Service Information no. 216

Changes at Foamatic – NEW Corona Technology!

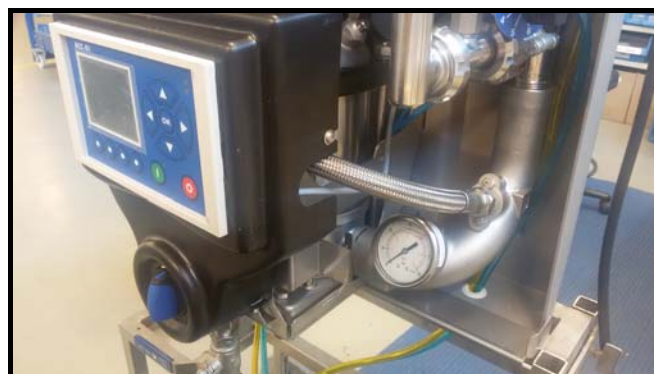
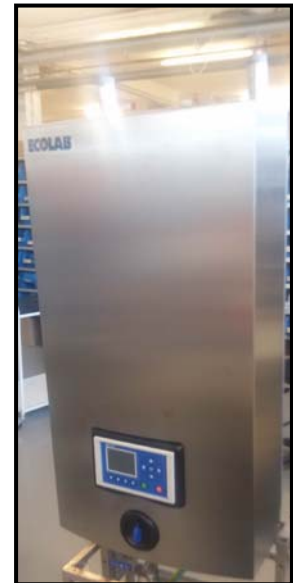
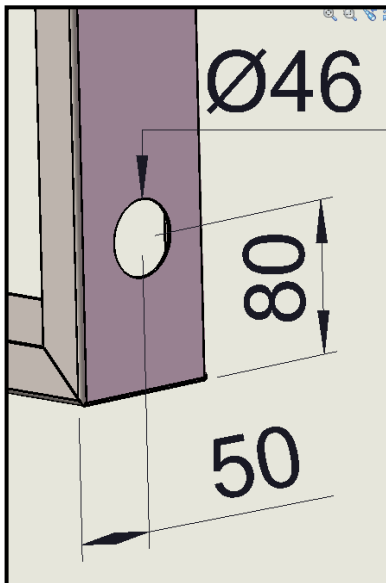
The manual outlet has been changed at the Foamatic Satellite and Foamatic Main-station, due to new hygienic weldings and new technology.

Furthermore, there have been some changes in hoses and flow-switch.

In the Main-station and Satellite the block has changed into the NEW Hybrid block – this means a new technology with one outlet instead of two - plus Corona foam.

In the Satellite the hoses for suction have been changed into 9/6 mm type – both for manual and automatic part. Changes are compatible with the older version – need to add an Ø46 hole to the cabinet. Complete number for NEW manual block for Foamatic Satellite in Hybrid version is - 110003908.

The Main-station has been turned into a Hybrid design with new cover and block. -So different design – same improved functionality. The flow-switch has been changed to a ¼" threaded model. Older version of Foamatic Mainstation can be rebuilt into Hybrid / Dou block – cover parts have to be changed. The new Foamatic Main-station has new item numbers please see next page.
